FED. ROAD DIS. NO.	STATE	FED. AID PROJ. NO.	FISCAL YEAR	SHEET NO.	TOTAL SHEETS
HAWAII	HAW.	I-H3-1(59)	1993	ADD.31	211

STATE OF HAWAII DEPARTMENT OF TRANSPORTATION HIGHWAYS DIVISION	
GRADING NOTES EROSION AND SEDIMENT CONTROL MEASURES	
INTERSTATE ROUTE H-3 F.A.I. PROJECT NO. I-H3-1(59)	
SCALE: AS NOTED	DATE: JUNE 1993
SHEET No. D1 OF 32 SHEETS

ADD. 31

9/30/93	REVISION
DATE	REVISION
STATE OF HAWAII DEPARTMENT OF TRANSPORTATION HIGHWAYS DIVISION	
GRADING AND DRAINAGE PLAN	
STA. 386+00 TO STA. 397+00	
INTERSTATE ROUTE H-3 F.A.I. PROJECT NO. I-H3-1(59)	
SCALE: 1" = 40'	DATE: JUN 1993
SHEET NO. 03 OF 32 SHEETS

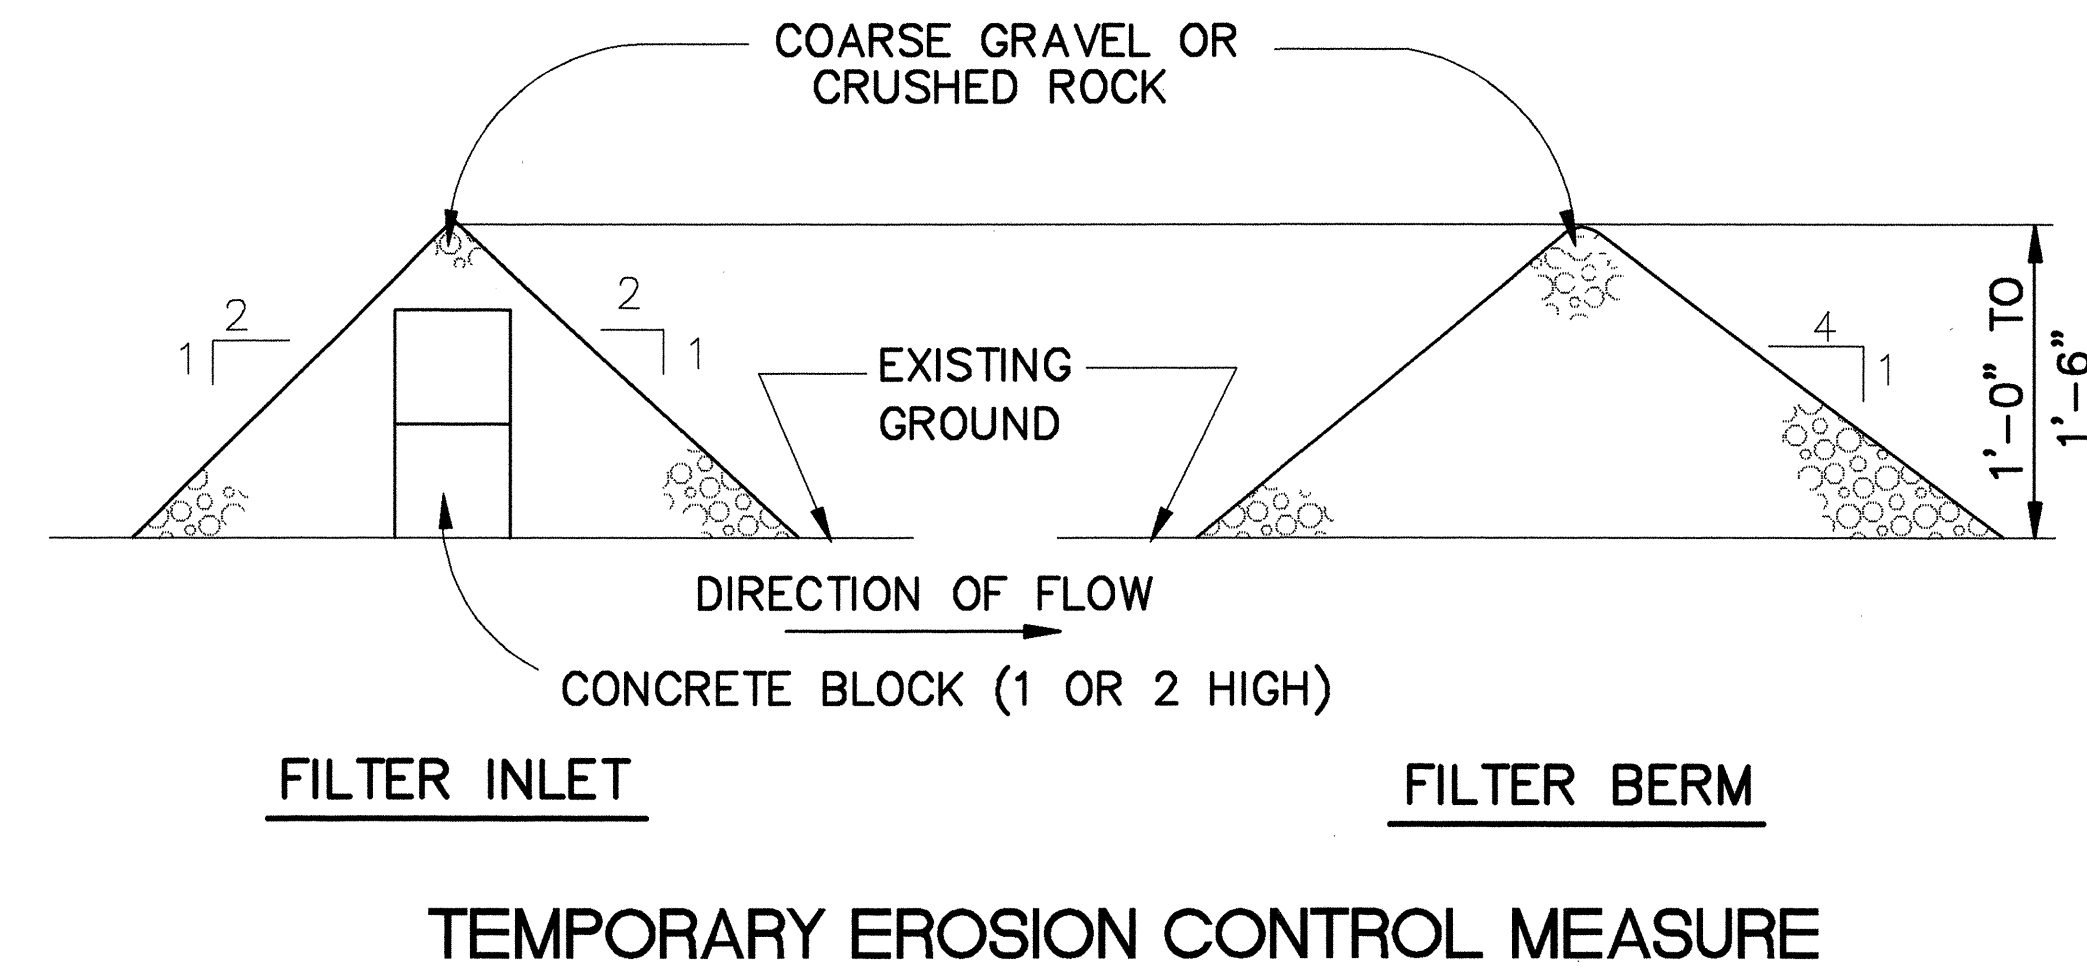
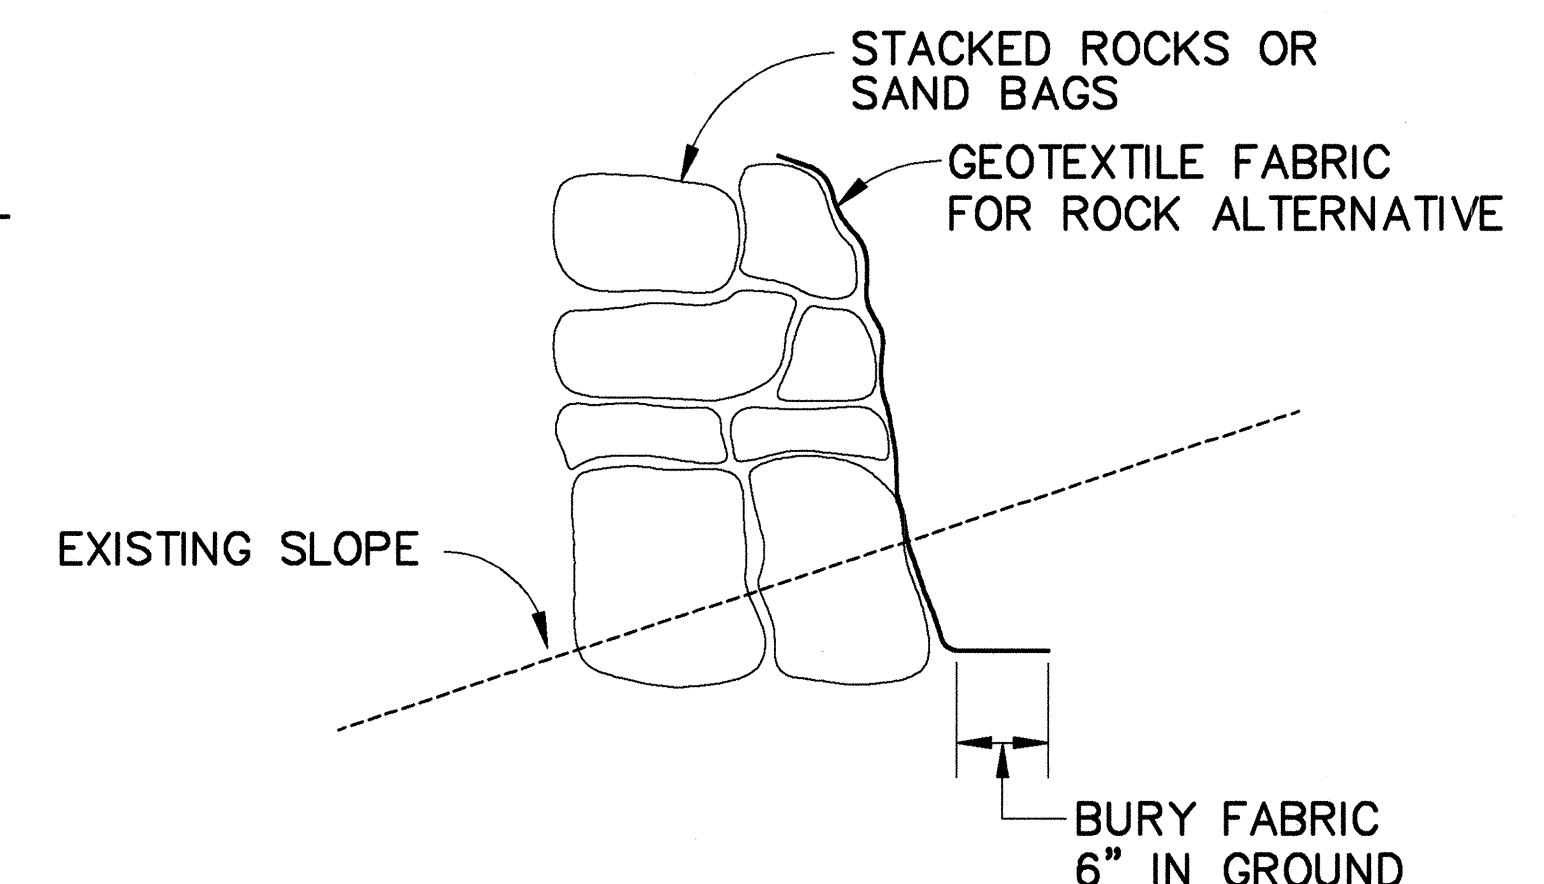
9/30/93	REVISED ESTIMATED QUANTITIES AND NOTE 4.
DATE	REVISION

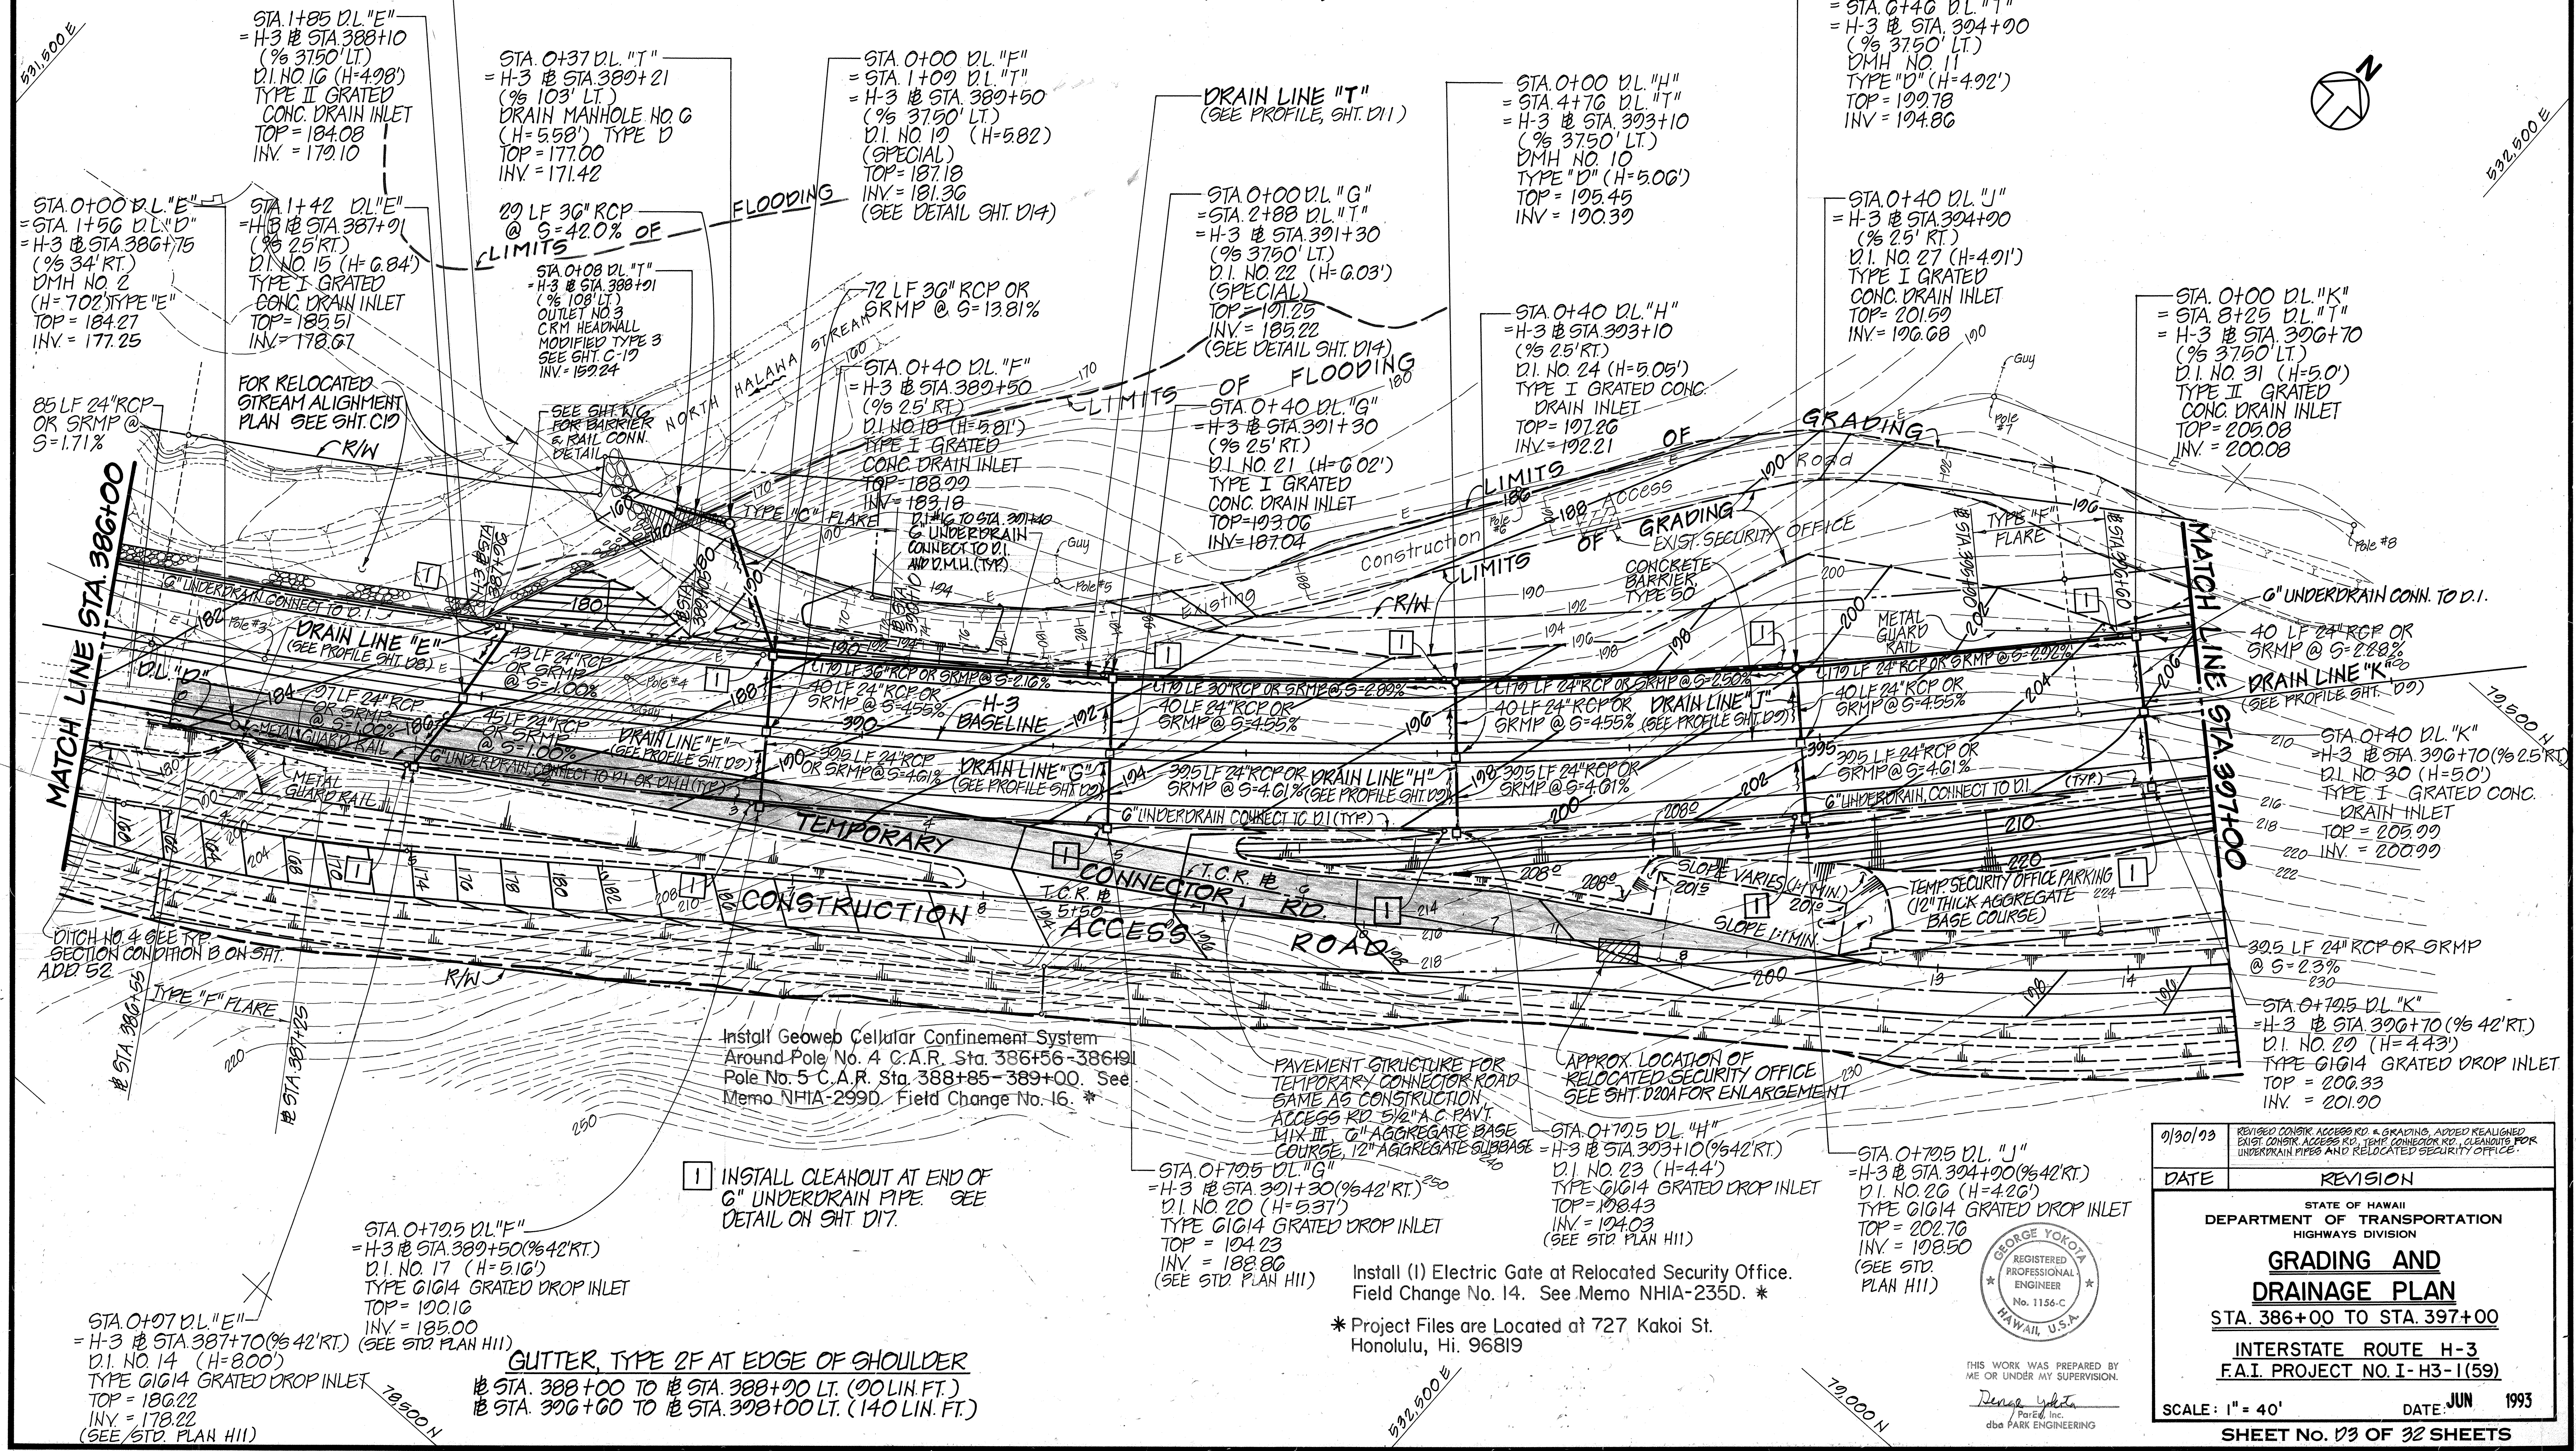
Install (I) Electric Gate at Relocated Security Office.
Field Change No. 14. See Memo NHIA-235D. *

SHEET No. 14 OF 32 SHEETS

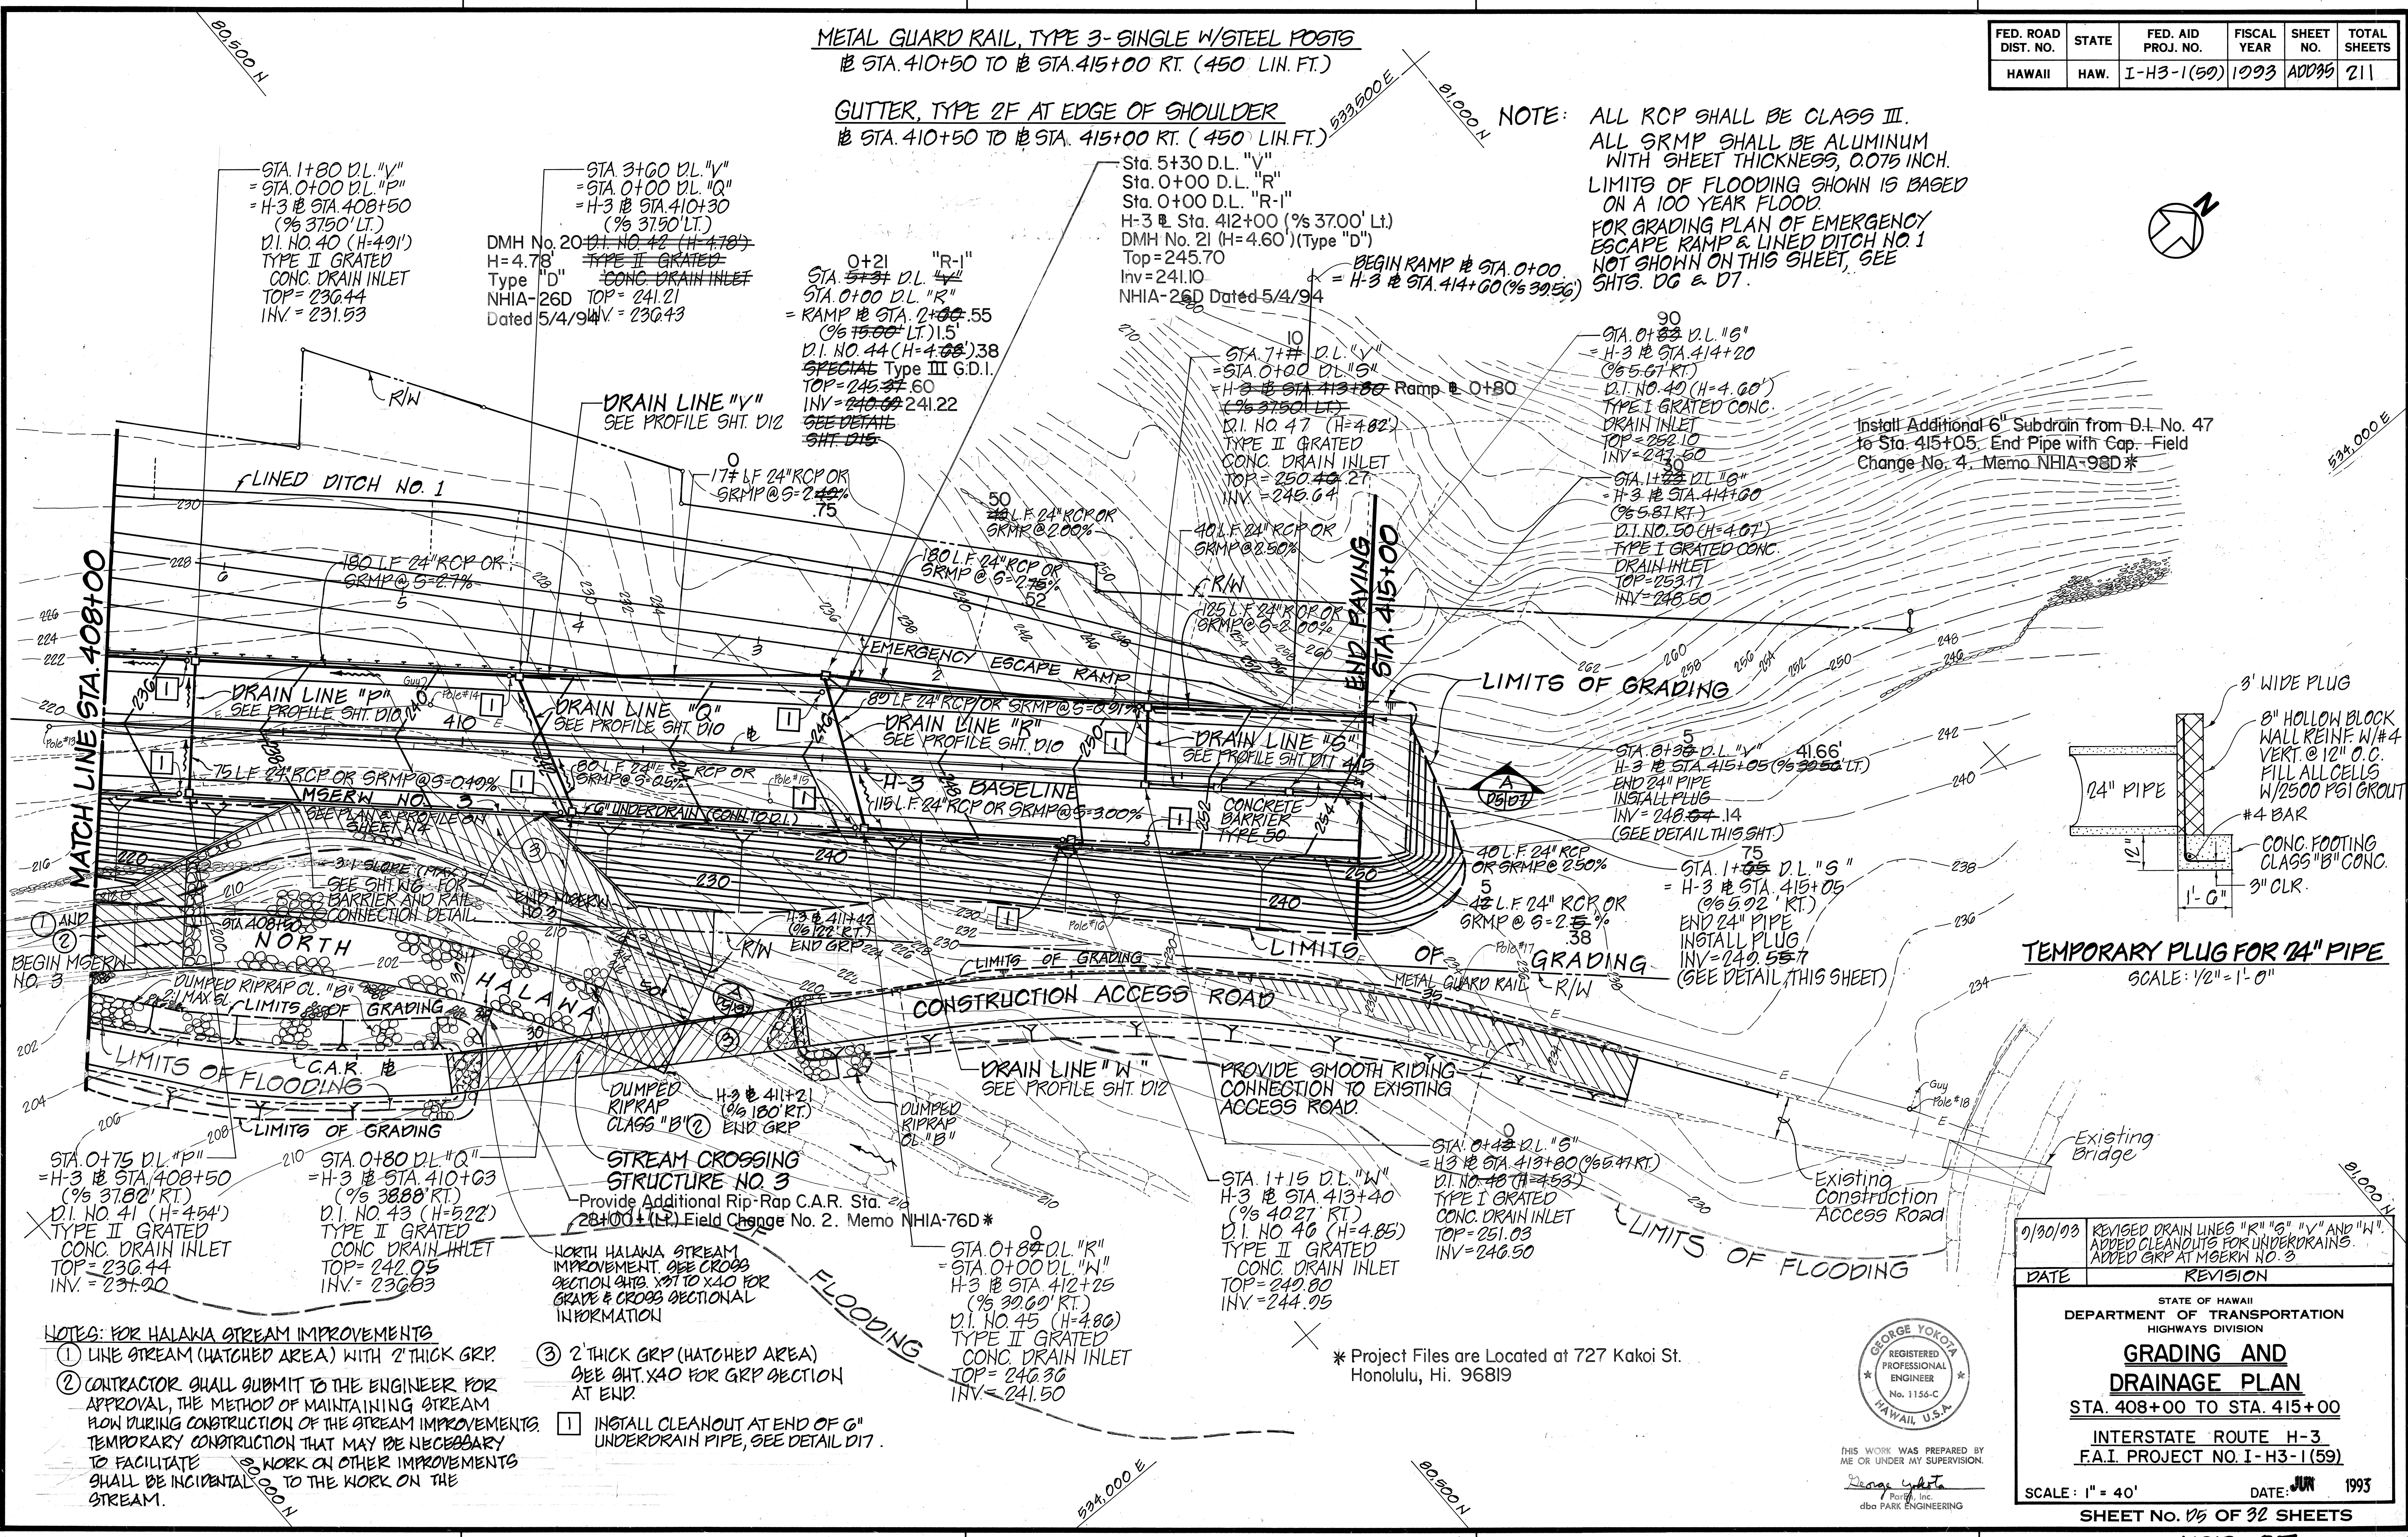
0.30/03	REVISIONS: 1. <u>CONST. ACCESS RD. & GRADING, ADDED</u> 2. <u>CLEANOUTS @ UNDERDRAIN PIPES, & UNDERDRAIN AT 401+30</u> 3. <u>W/ICLEANOUT & CONN. TO D.I.</u>
DATE	REVISION
